ATTACHMENT A

MAJOR HIGHLIGHTS OF PROPOSED AMENDMENT NO. 155 REVISION 2 AND REVISION 1

MAJOR HIGHLIGHTS OF PA 155 REV. 2 - RETS

FIGURE 8.1-1 EXCLUSION AREA

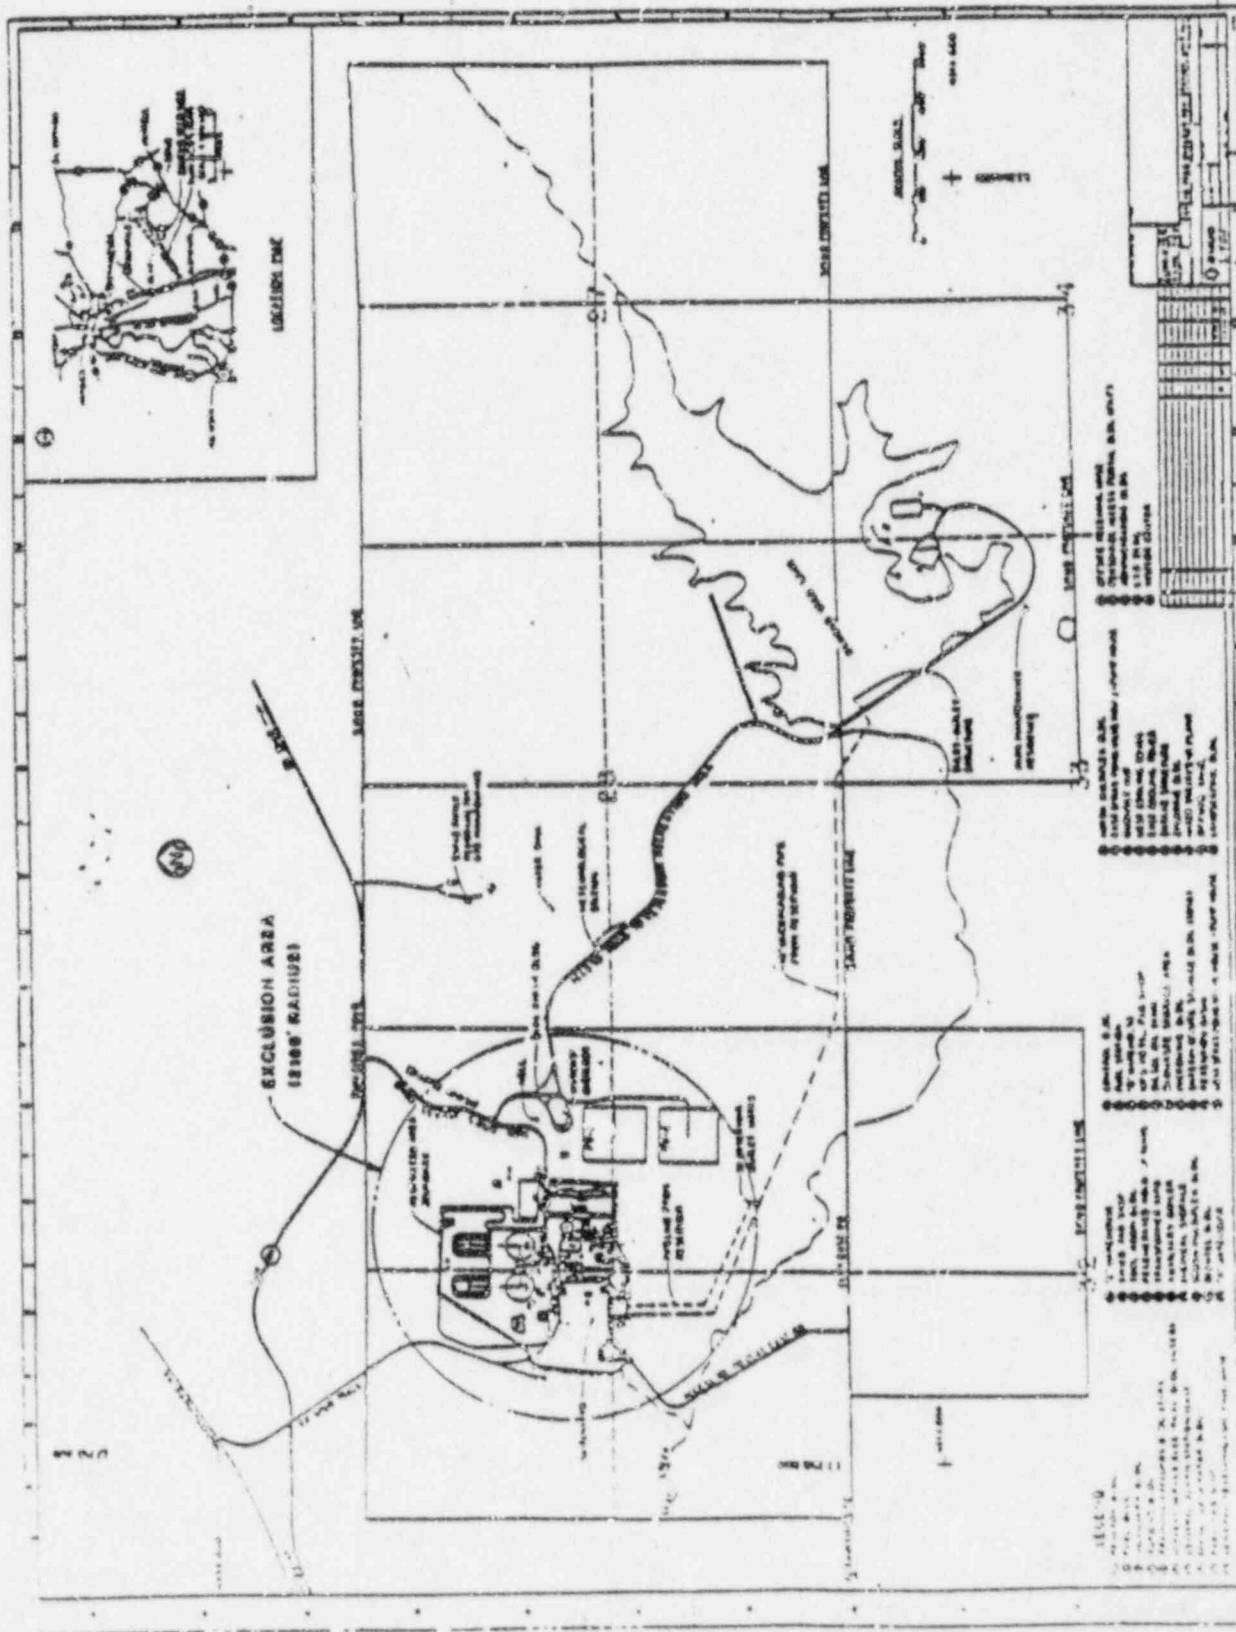
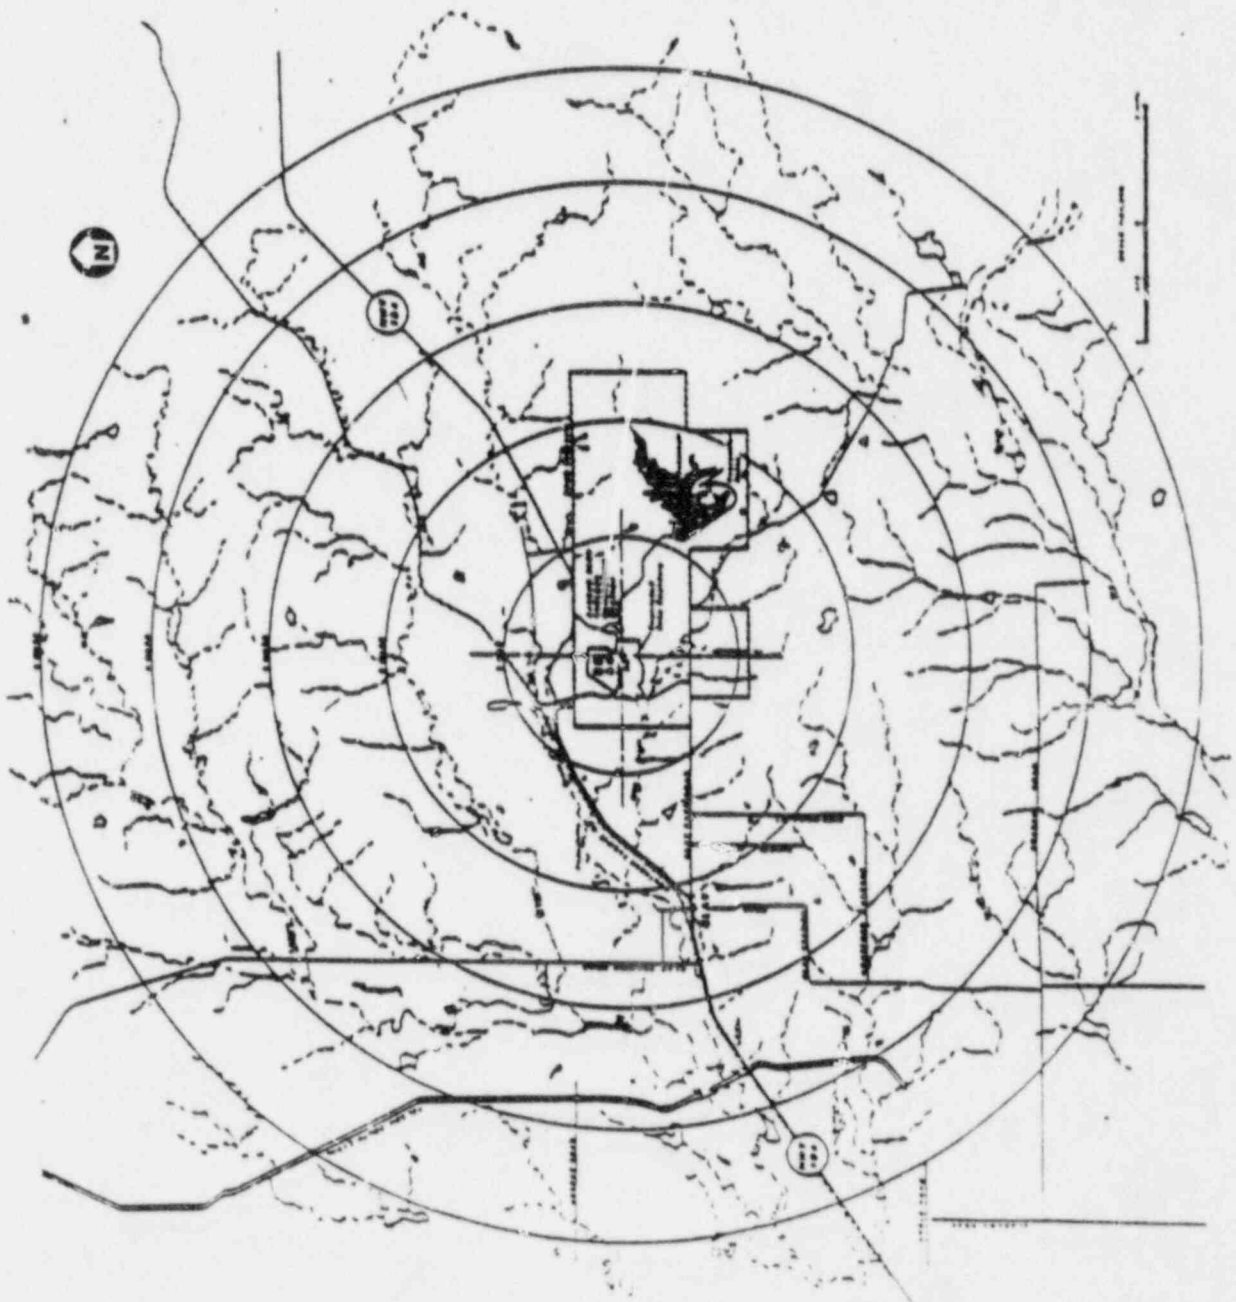
The EXCLUSION AREA shall be shown in Figure 5.1-1.

The addition of site schematic drawings identifying the affected areas of effluent release is pursuant with the Standard RETS.

EXCLUSION AREA

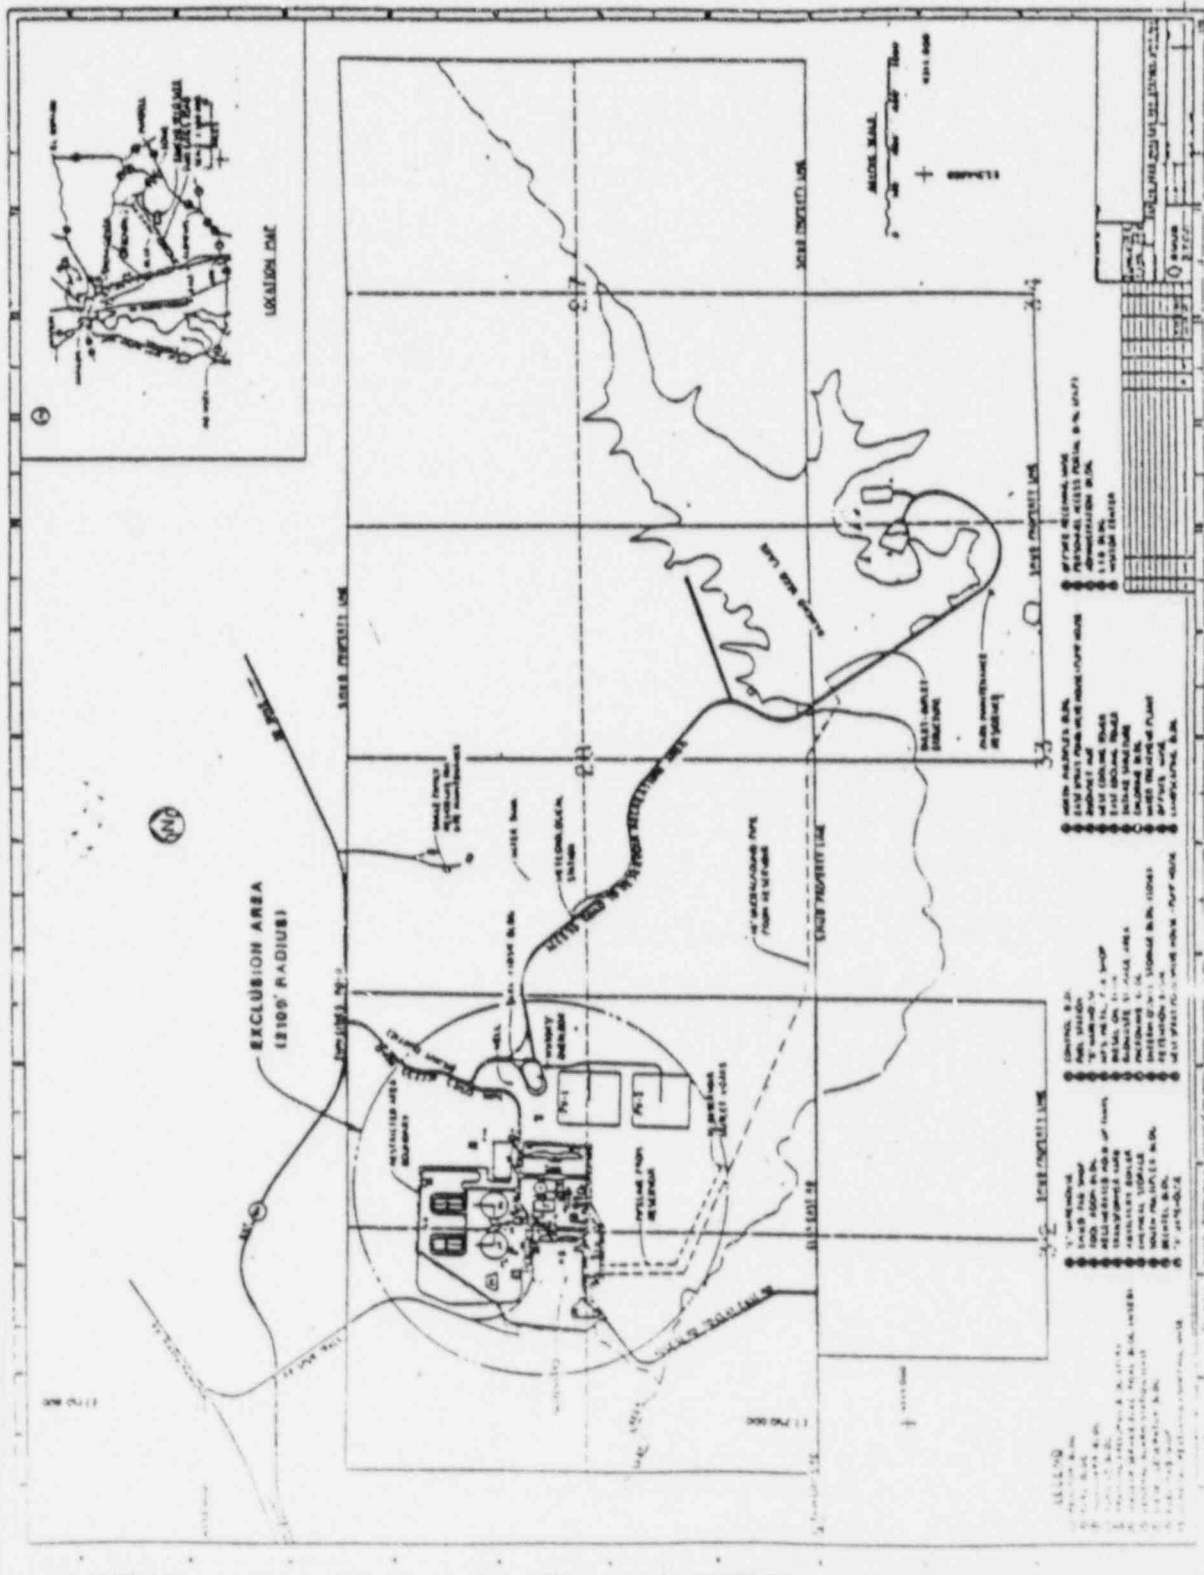
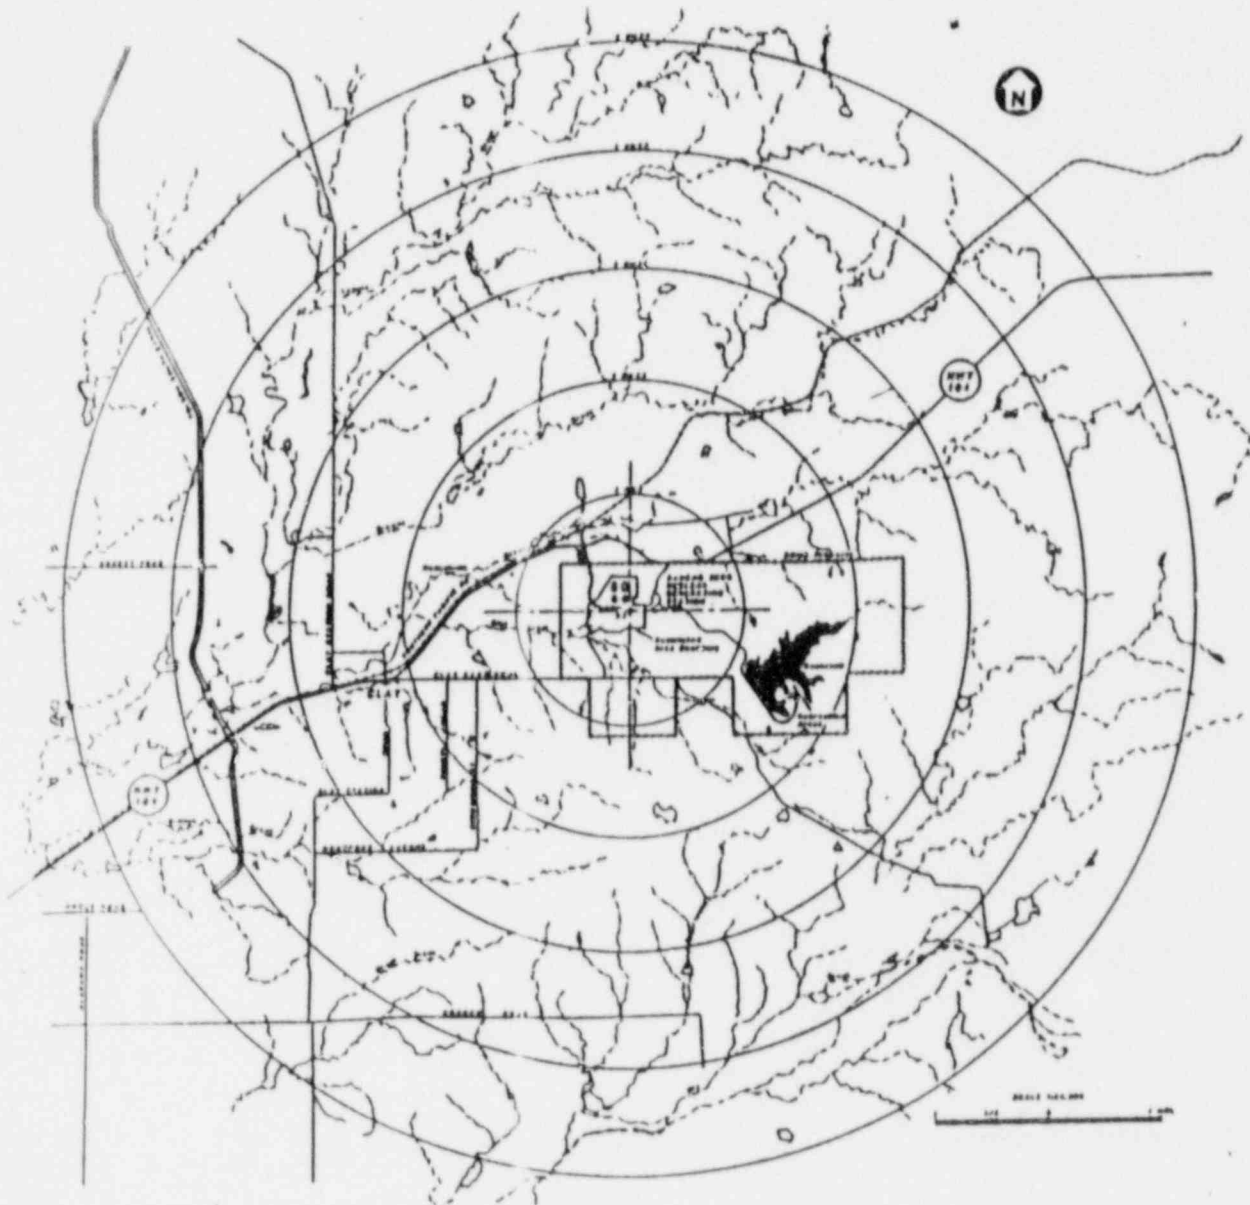
The EXCLUSION AREA shall be shown in Figure 5.1-1.

FIGURE 5.1-2
LOW POPULATION ZONE
(5 mile radius)

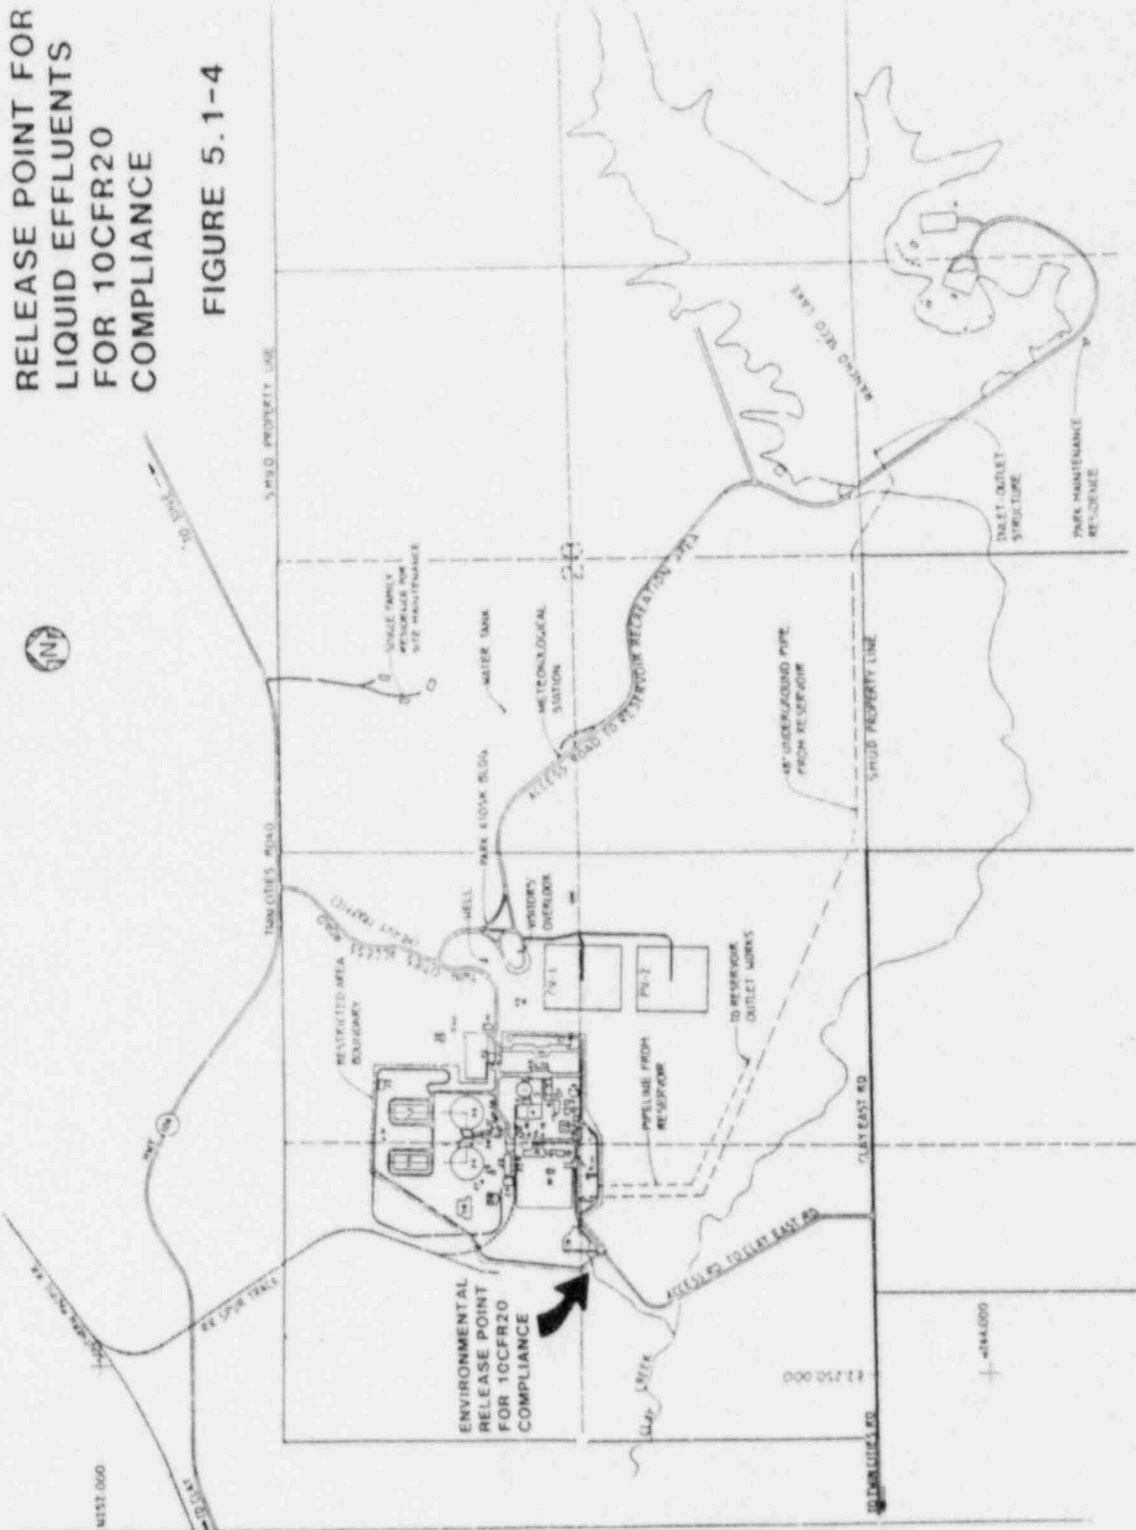
The LOW POPULATION ZONE shall be shown in Figure 5.1-2.
